**Planning Commission
Wednesday, November 20, 2024
4:00 PM**

Agenda Item Summary

AGENDA ITEM: Resolution No. 7, Series of 2024: Little Red School House
Special Review and Subdivision Plat

SUBDIVISION PLAT OF THE
LITTLE RED SCHOOL HOUSE AND COMMUNITY PLAYGROUND
PARCELS OF LAND SITUATED IN NW1/4 SECTION 6, TOWNSHIP 10 SOUTH,
RANGE 85 WEST OF THE 6TH PRINCIPAL MERIDIAN
TOWN OF SNOWMASS VILLAGE, COUNTY OF PITKIN, STATE OF COLORADO

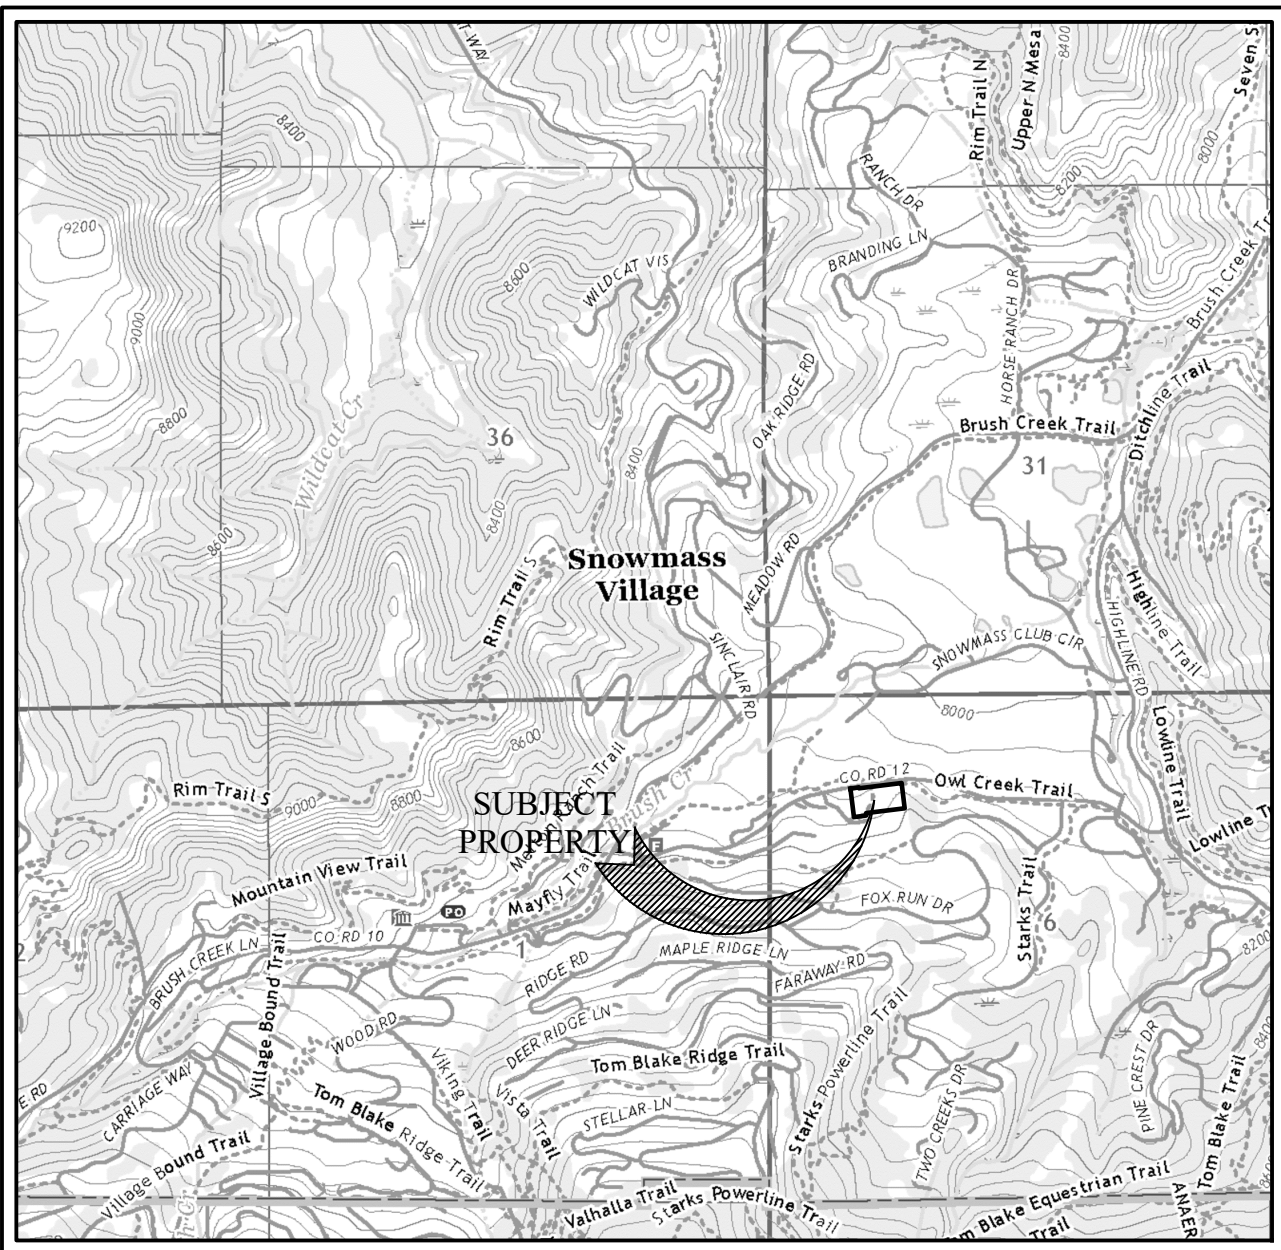
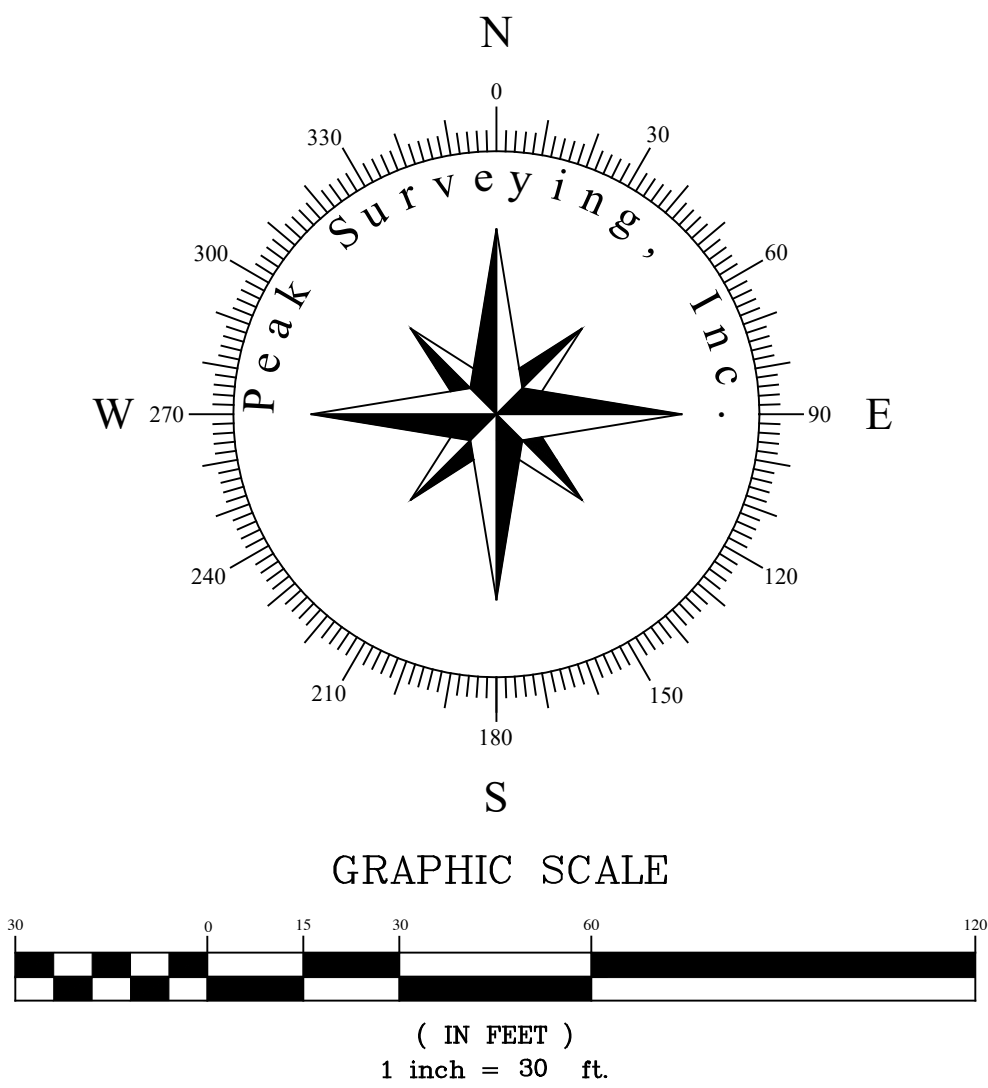
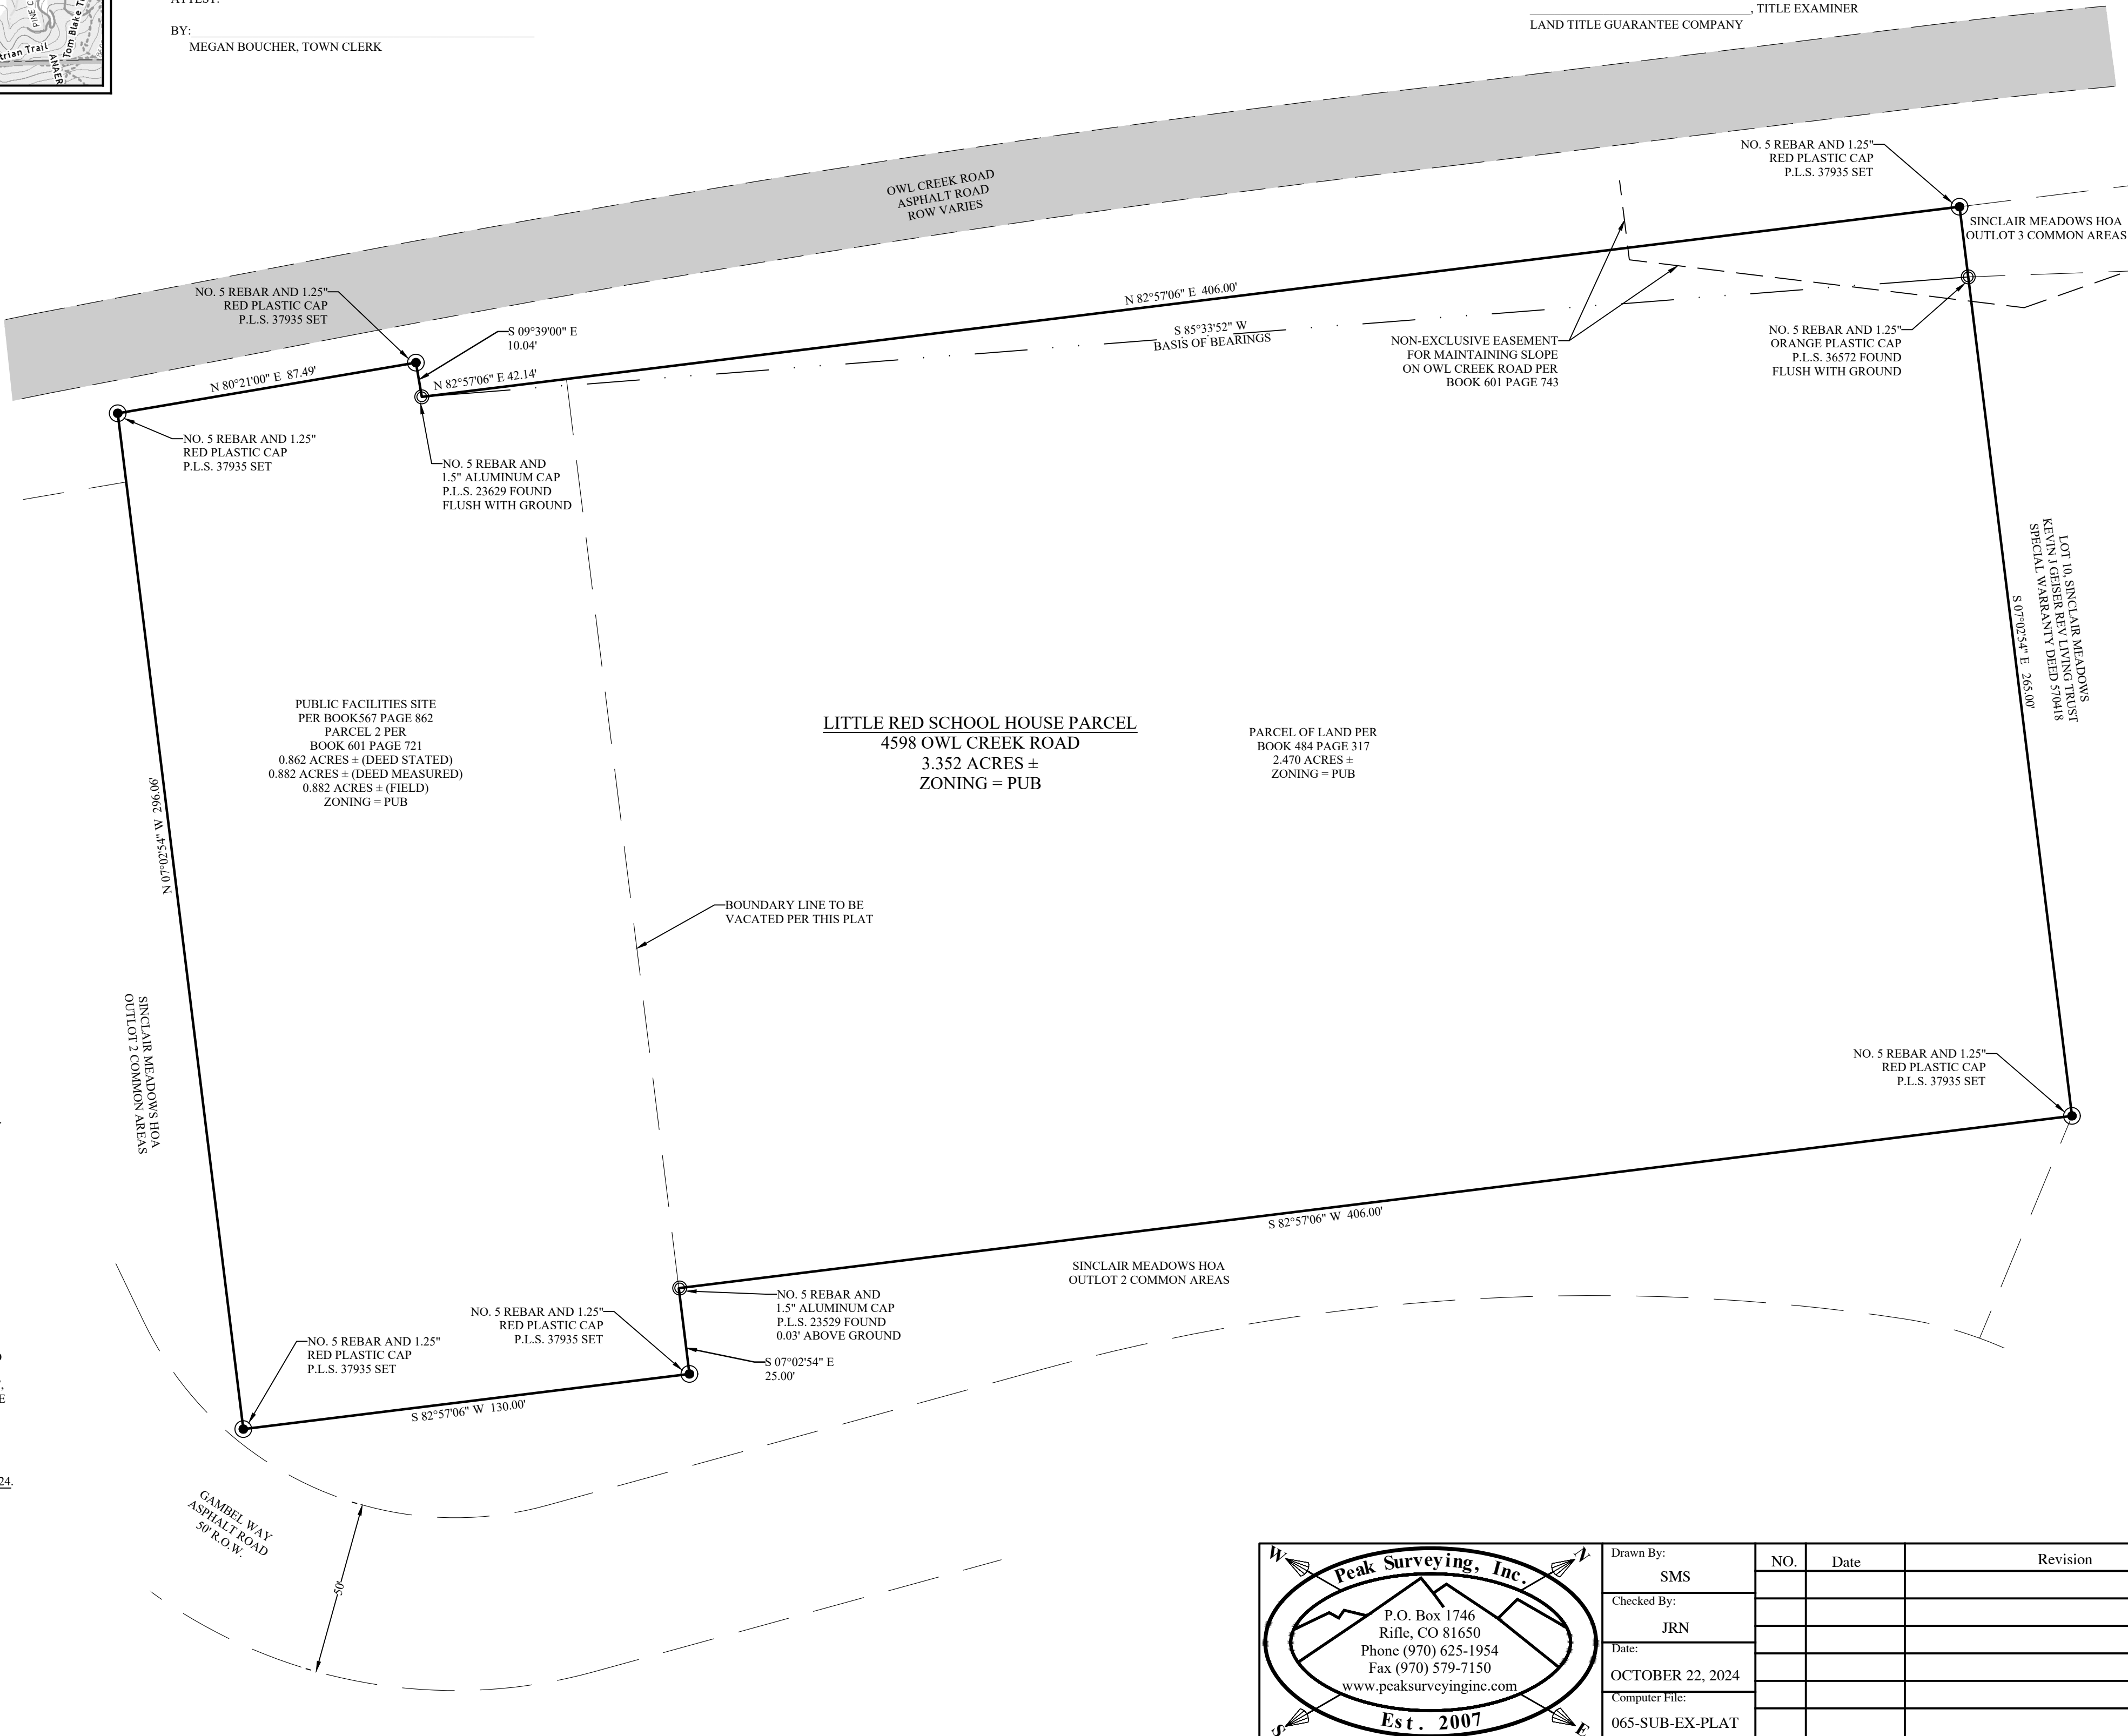
- Reference the attached plat exhibit for revisions requested.

SHEET NO.
G100

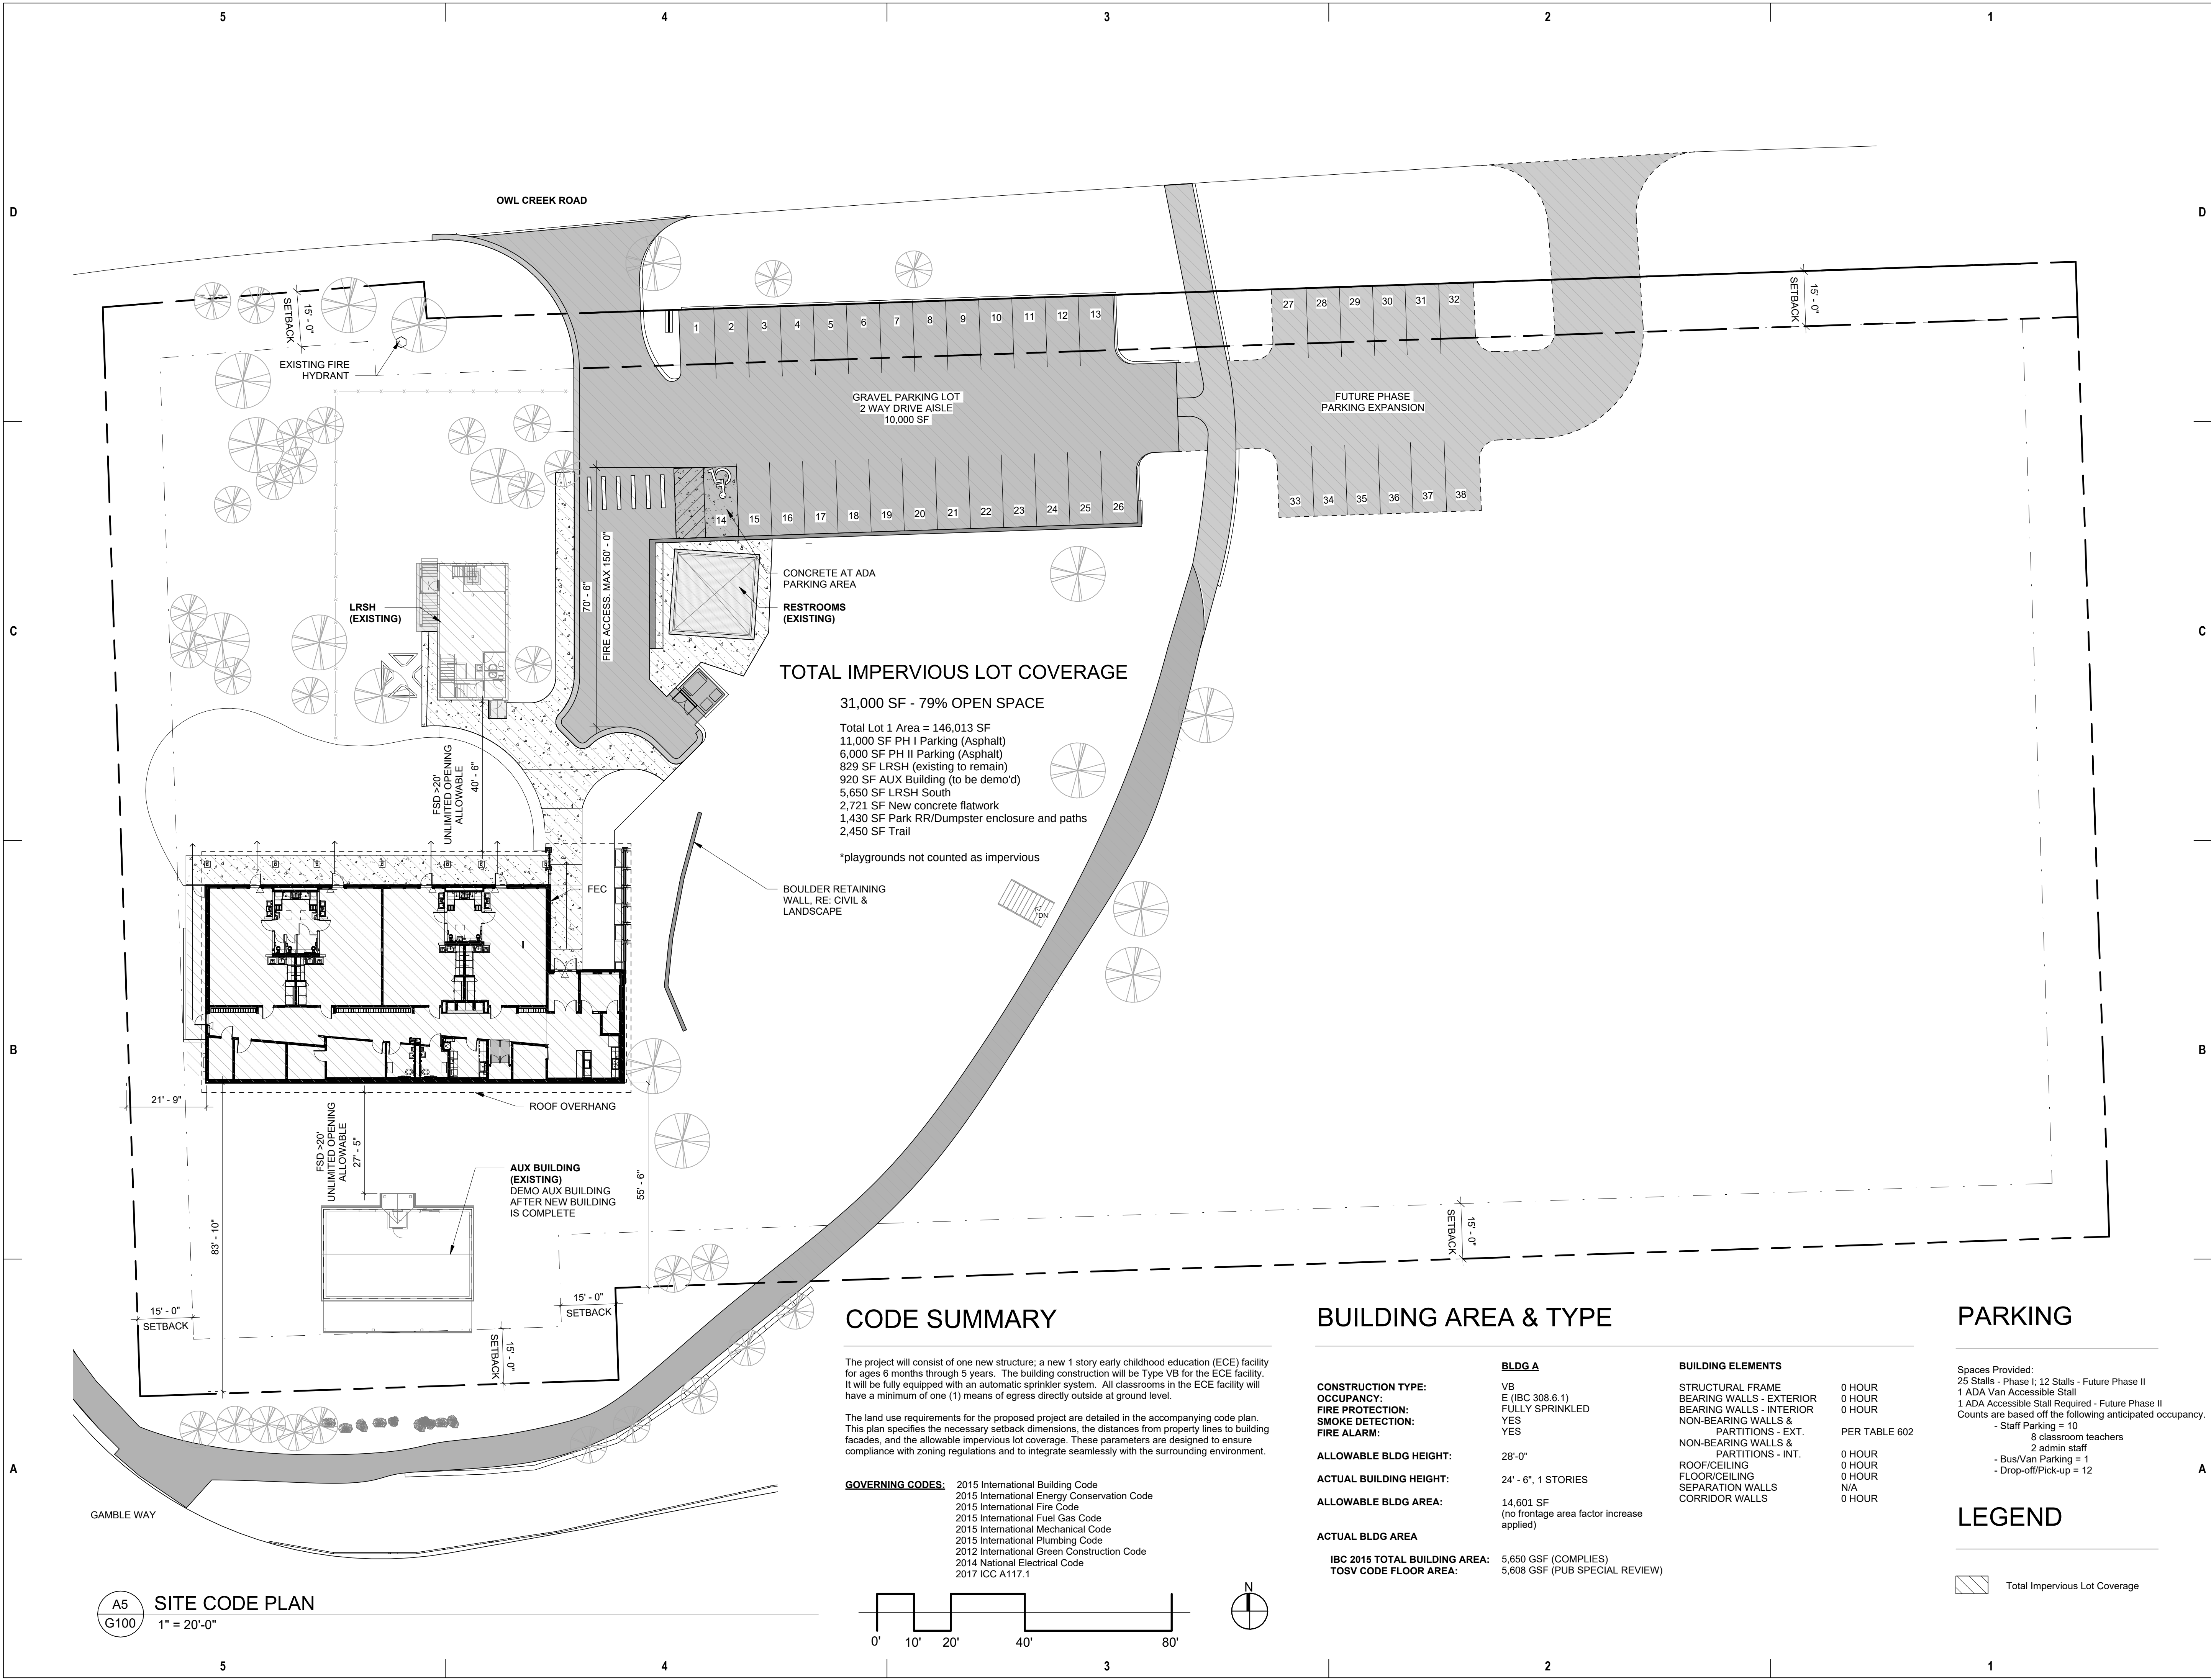
- Primary Building Height 28' maximum height (removed story reference and revised permitted height on Sheet G100; LRSH max. height 23'-0", documented on sheet A201)
- Accessory Building Height 12' maximum height
- Fence proposed at 6' H and all gate locations shown on landscape plan, reference sheet L1.1
